**TOWN OF NEWBURGH
PLANNING BOARD
TECHNICAL REVIEW COMMENTS**

PROJECT: NEWBURGH PARK ASSOCIATES (NPA)
PROJECT NO.: 2017-03
PROJECT LOCATION: SECTION 89, BLOCK 1, LOT 19.22
REVIEW DATE: 7 AUGUST 2018
MEETING DATE: 16 AUGUST 2018
PROJECT REPRESENTATIVE: ZEN DESIGN CONSULTANTS

ENGINEER WILLIAM J. MOREAU	PROPOSED SITE PLAN NEWBURGH PARK ASSOCIATES, INC. SEPTIC DETAILS SBL: 89-1-19.22 TOWN OF NEWBURGH, ORANGE COUNTY, NY		
	DATE 7/7/2016	SCALE 1"=30'	SHEET NUMBER 4 OF 5

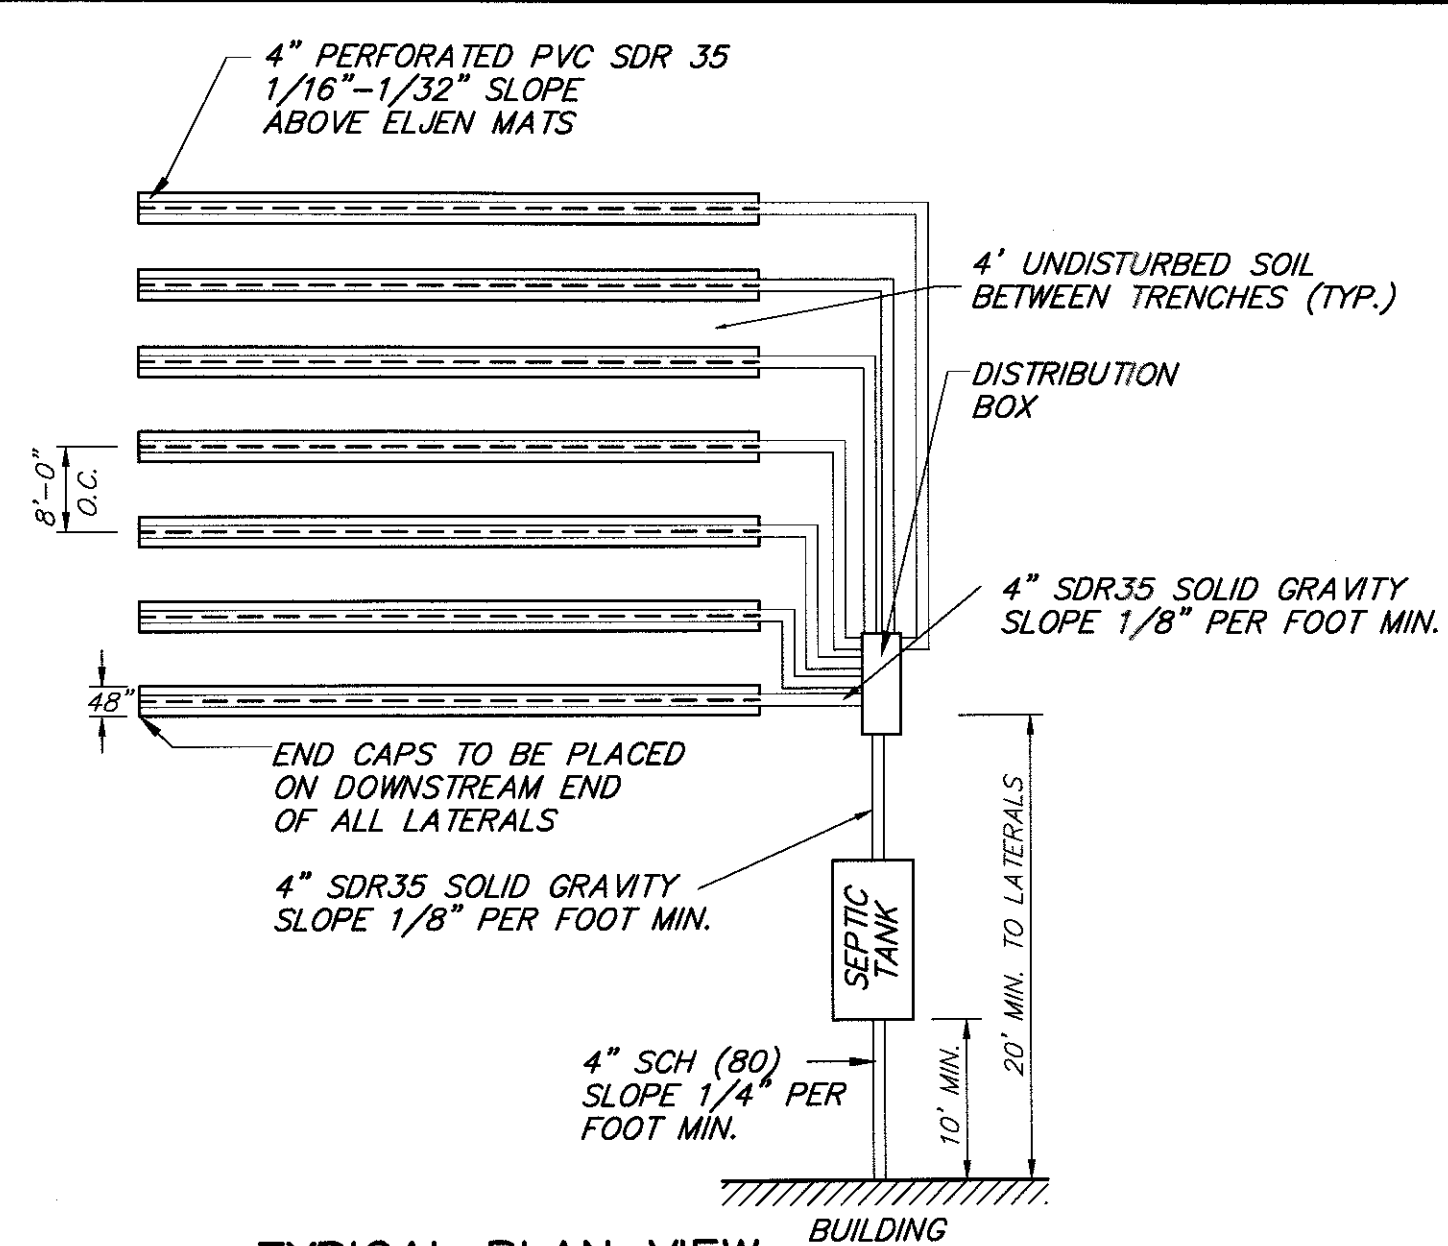
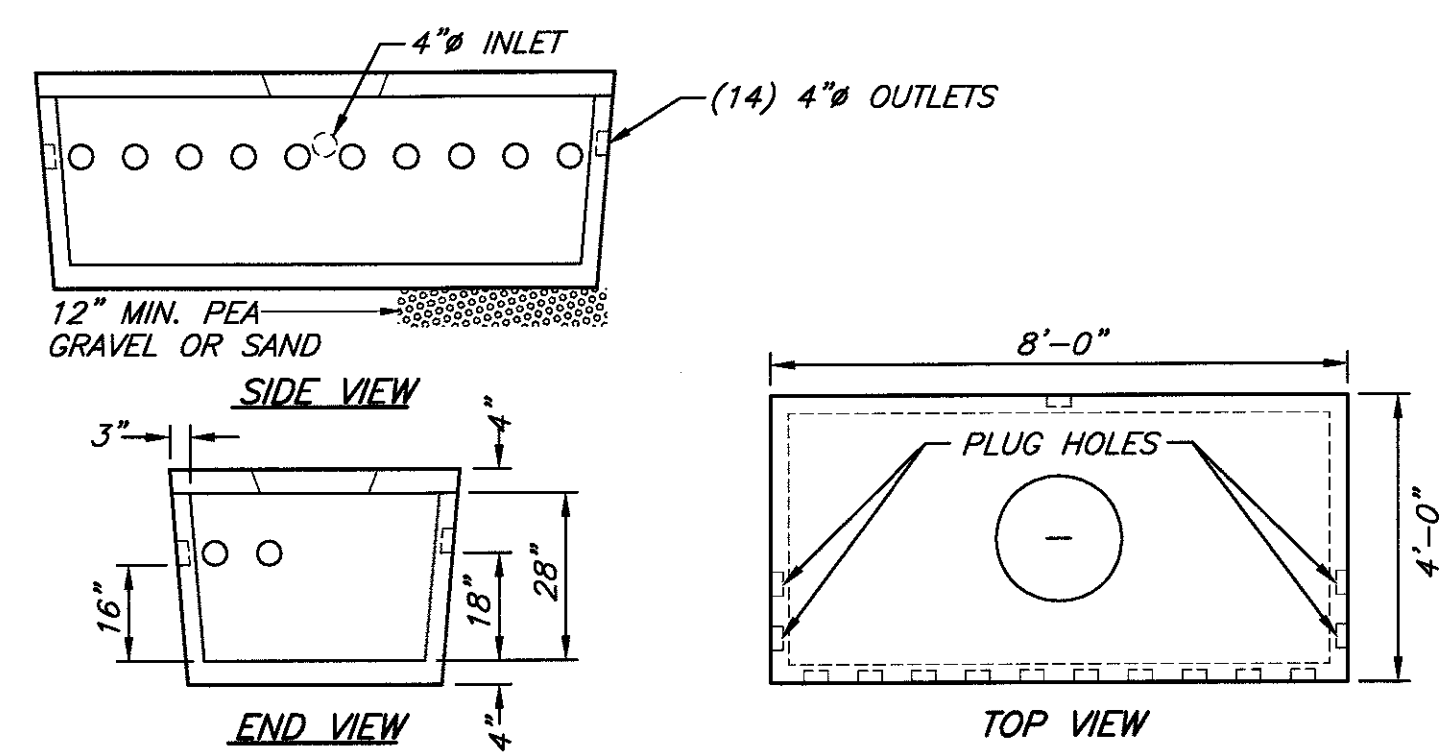
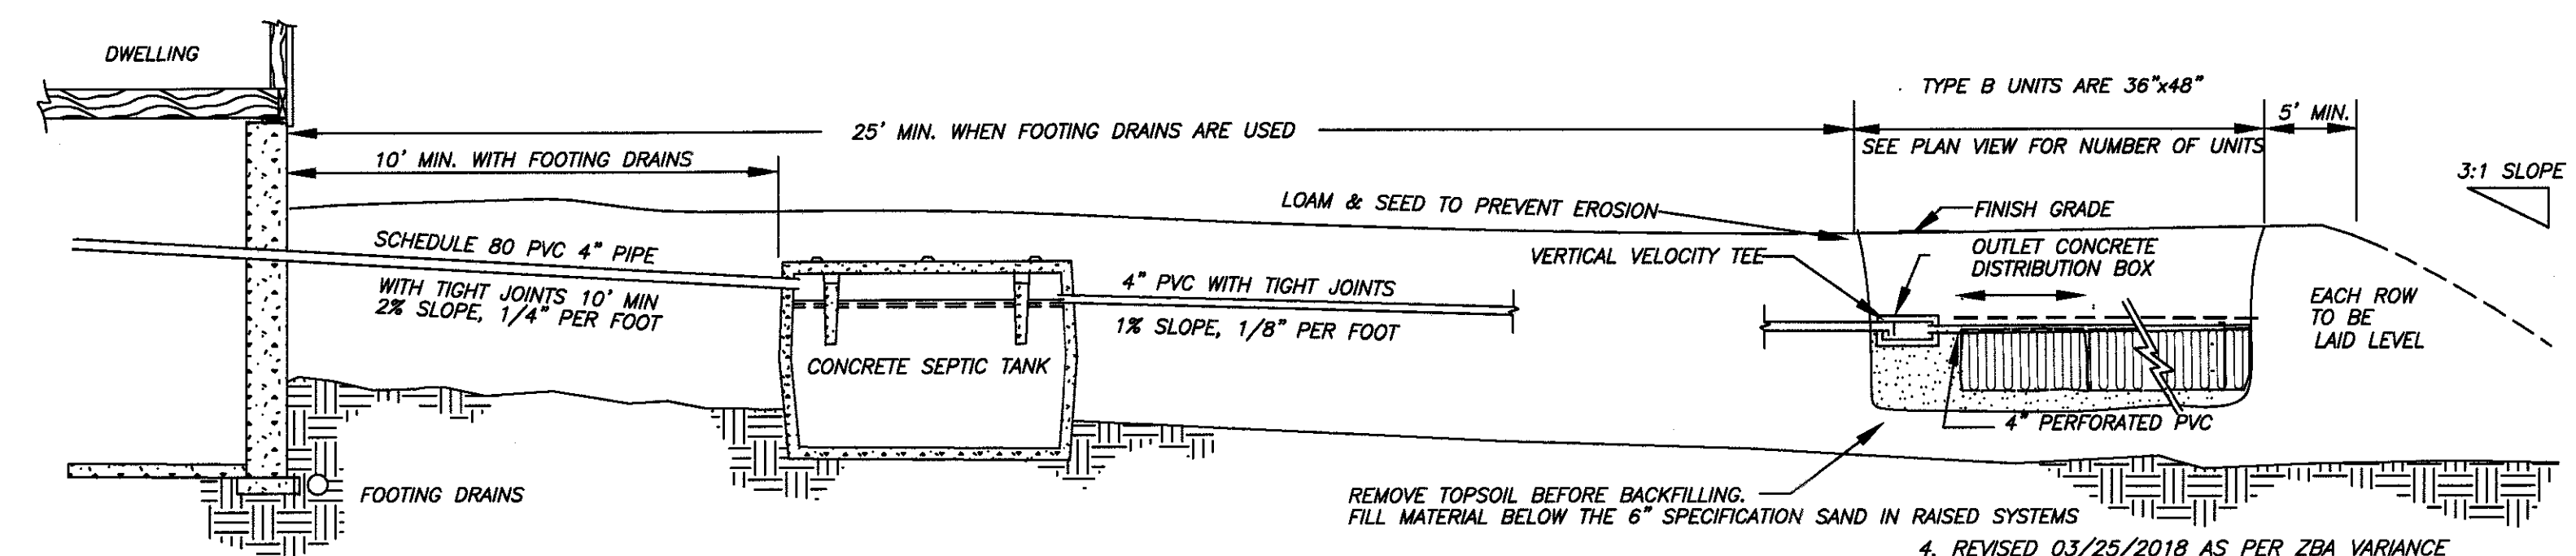
11. Town Certification on Sheet 4 of 5 references Town of Plattekill.
12. Design flow rate identifies the structure as 2,800 square feet as well as a toilet at 400 gallons per day. The project then totals the design flow at 400 gallons per day. No hydraulic loading from the actual building use is included in the plans. In addition any cleaning facilities/ kitchen areas should be addressed in the design flow rate.

ENGINEER WILLIAM J. MOREAU	PROPOSED SITE PLAN NEWBURGH PARK ASSOCIATES, INC. DRAINAGE & GRADING SBL: 89-1-19.22 TOWN OF NEWBURGH, ORANGE COUNTY, NY		
	DATE 7/7/2016	SCALE 1"=30'	JOB NUMBER 15-008-PMU
		SHEET NUMBER 3 OF 5

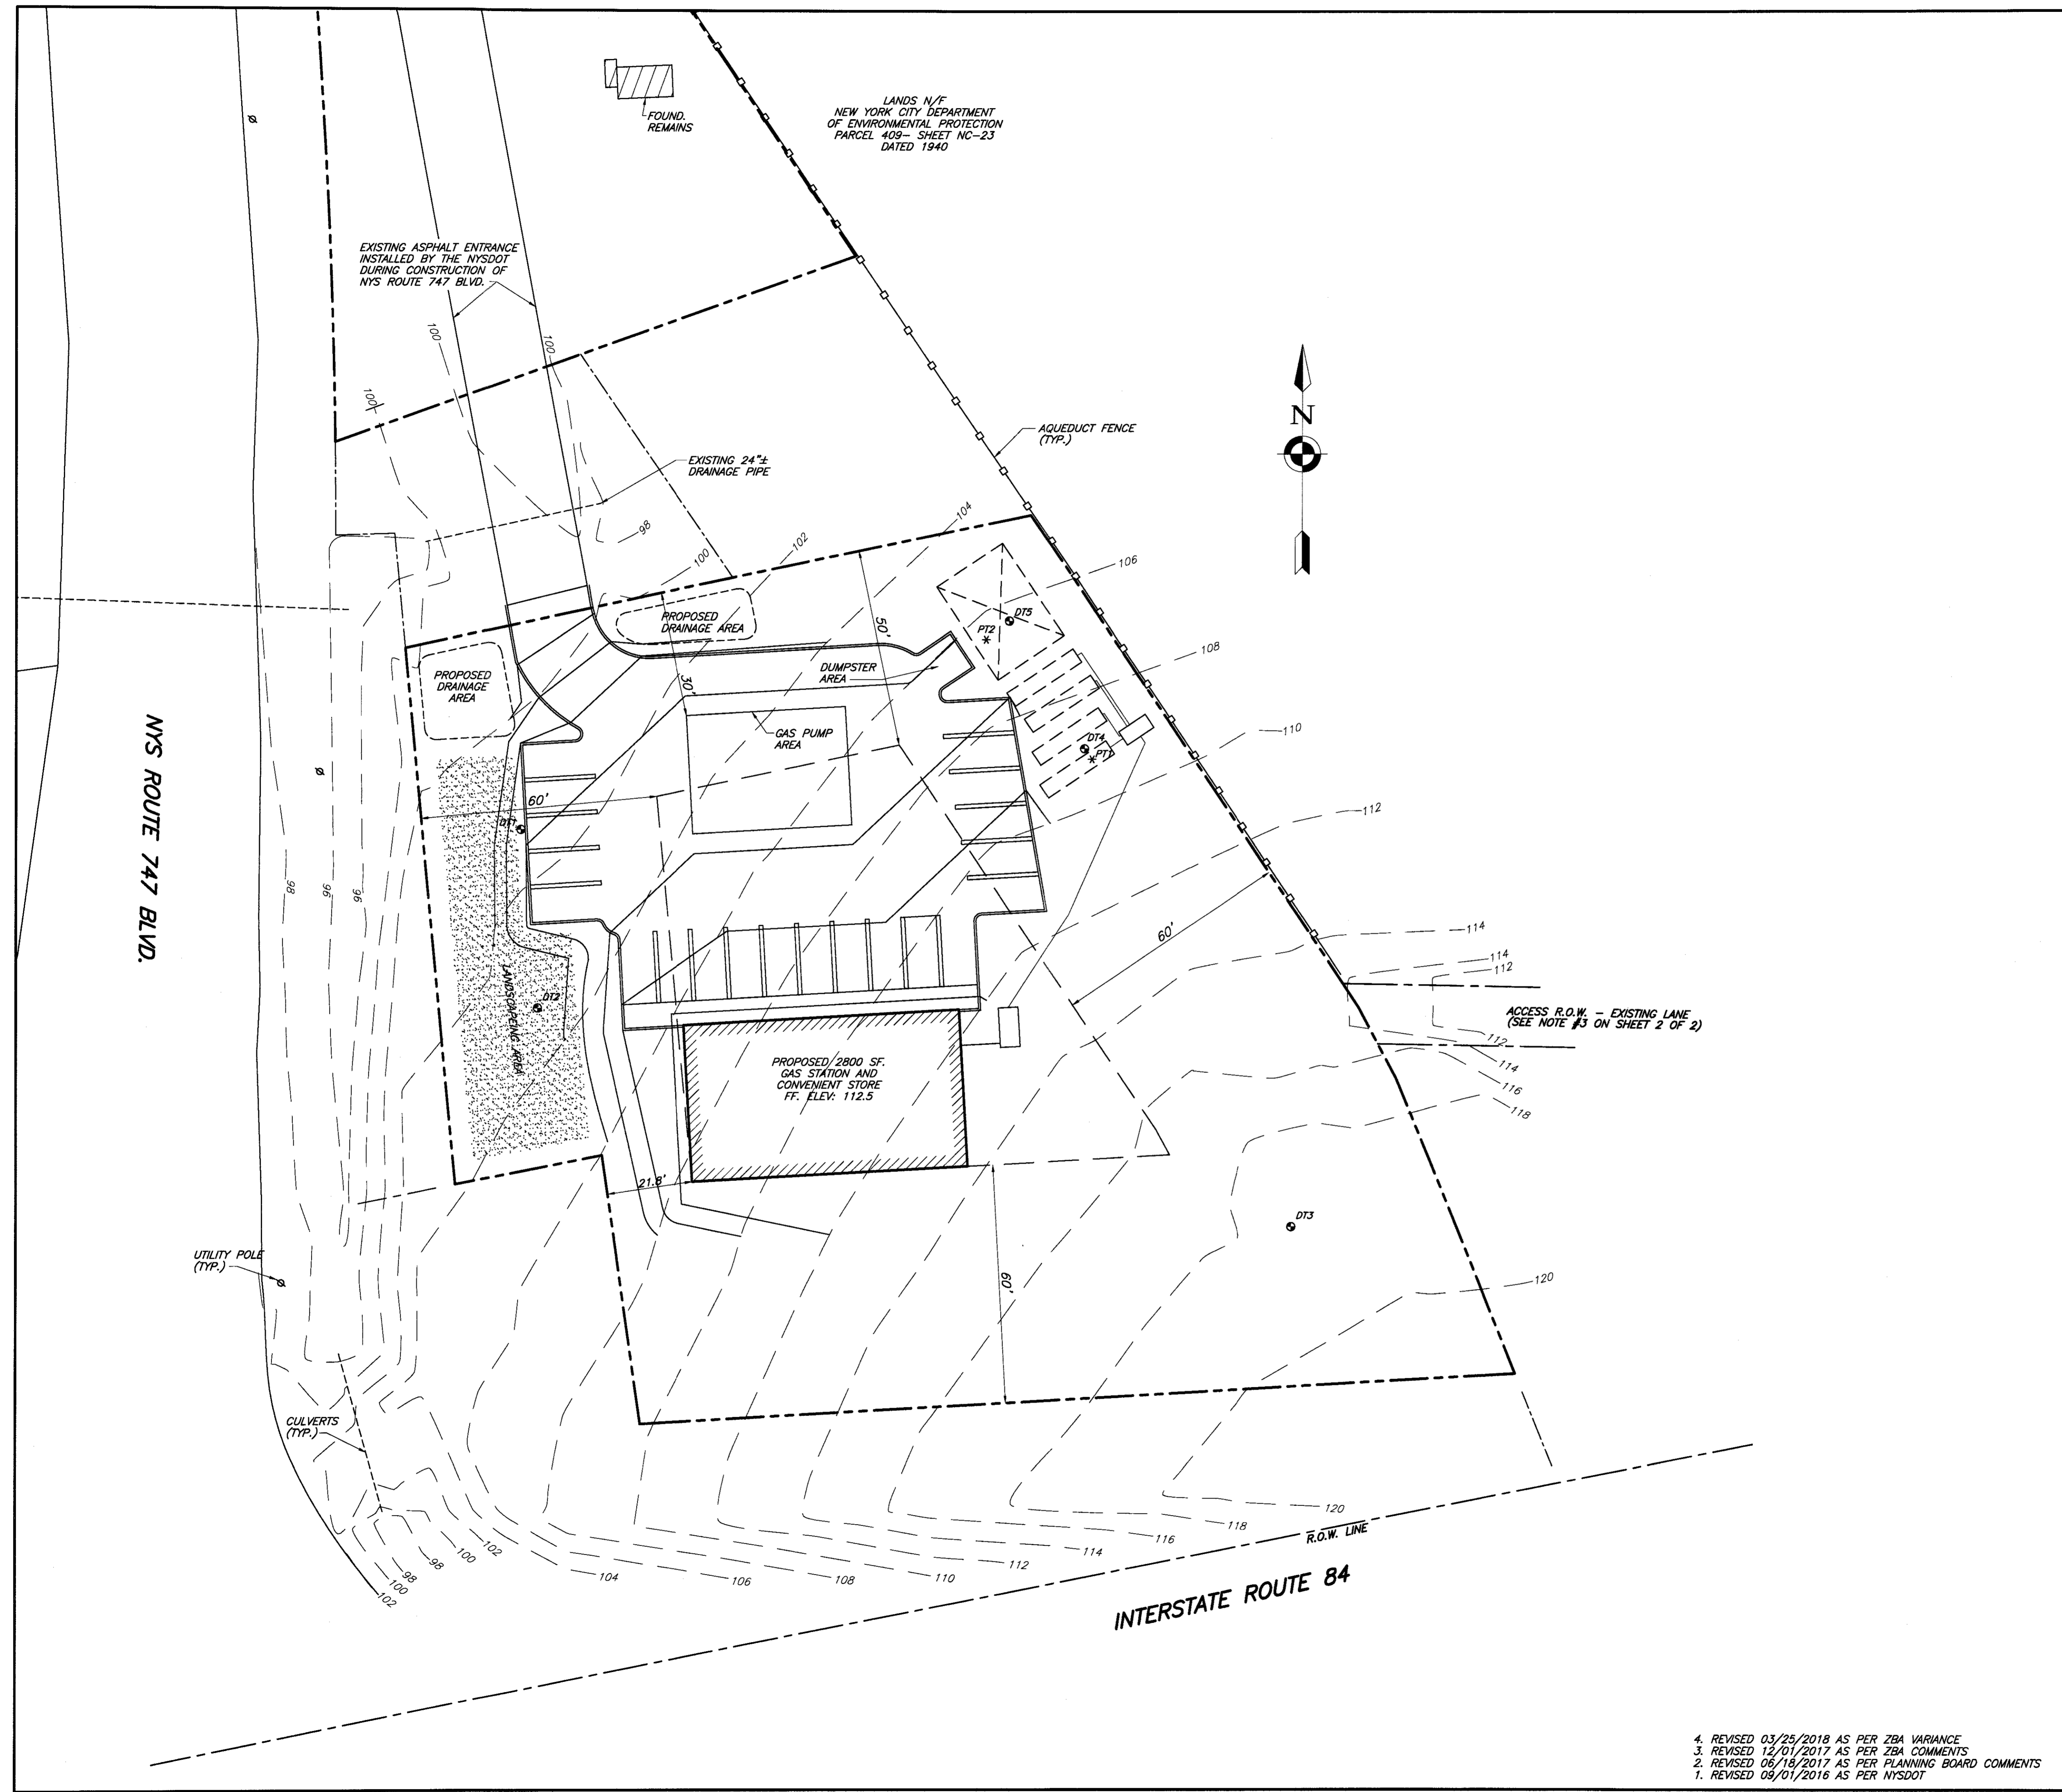
7. Future submission should contain site lighting and landscaping plans.
8. Sheet 3 of 5 is not to scale. Scale is identified as 1 inch = 30. However the plan sheet is not 30 scale based on dimensioning.
